Subject: External Mounted Heat Exchangers

Document Number: TAIB0859

Date: October 5, 2015

Issue Description:

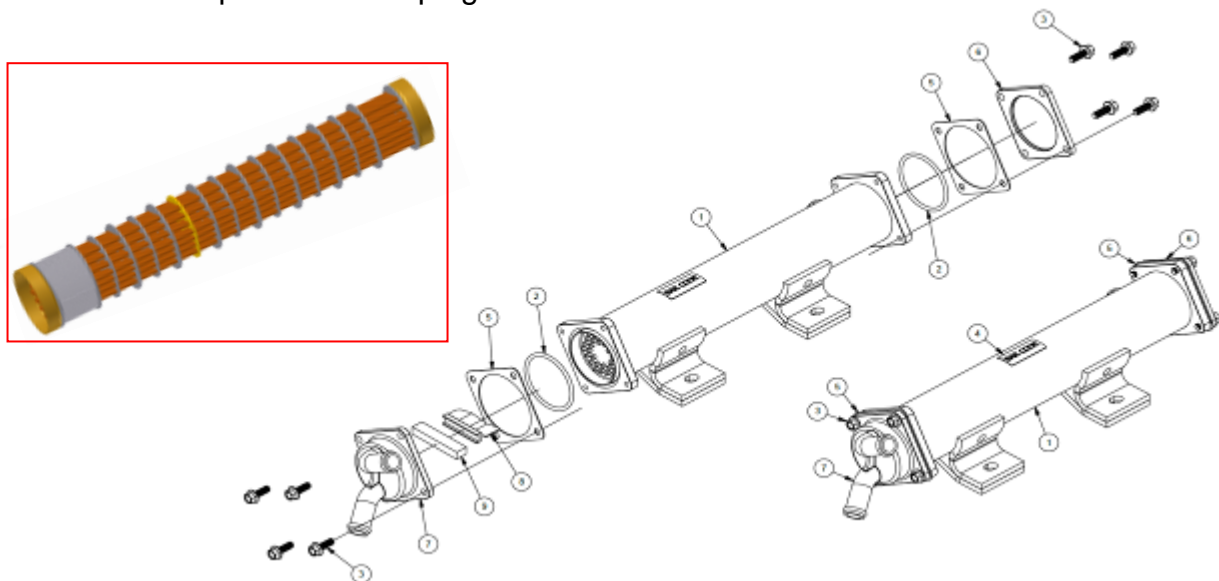
Eaton has released a new design heat exchanger replacing the below part numbers.

External cooler redesign will feature:

- Replaced fixed joint between the bundle and shell with full floating bundle style. This configuration will eliminate silver braze.
- Bundle supported in shell by O-rings that provide vibration isolation.
- Copper fins replaced with aluminum that eliminates the need for silver in brazing solder.
- Weight savings: 0.5 lbs.
- Flanged end bonnet design for coolant inlet / outlet configurations.
